**SINGAPORE TELECOMMUNICATIONS LIMITED AND SINGTEL MOBILE
SINGAPORE PRIVATE LIMITED**

**RESPONSE TO PUBLIC CONSULTATION ON THE REVIEW OF THE
CODE OF PRACTICE FOR INFO-COMMUNICATION FACILITIES IN
BUILDINGS (“COPIF”)**

Figure 1 Illustration of proposed structured cable system

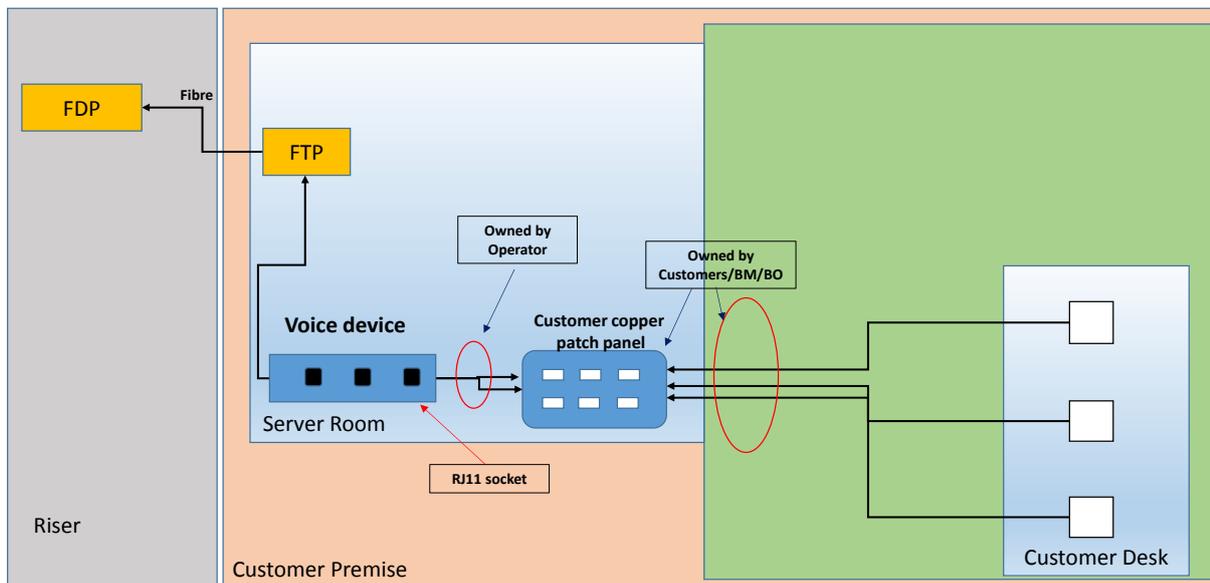
5.53. The revised COPIF should require that the building owner or tenant install a structured LAN cable infrastructure system which will allow customers to connect their equipment to a patch panel instead of directly to the Licensees' equipment; similar to the residential model. This ensures that the customer does not physically handle the Licensee's equipment

5.54. As illustrated in Figure 1, the structured cable system starts from a patch panel (preferably RJ45) with CAT6 cabling to the designated location (e.g. a cubicle) within the unit. The patch panel should have an AC power socket – also similar to the residential model – should be constructed near the air blow tubes [from the MDF room each unit].
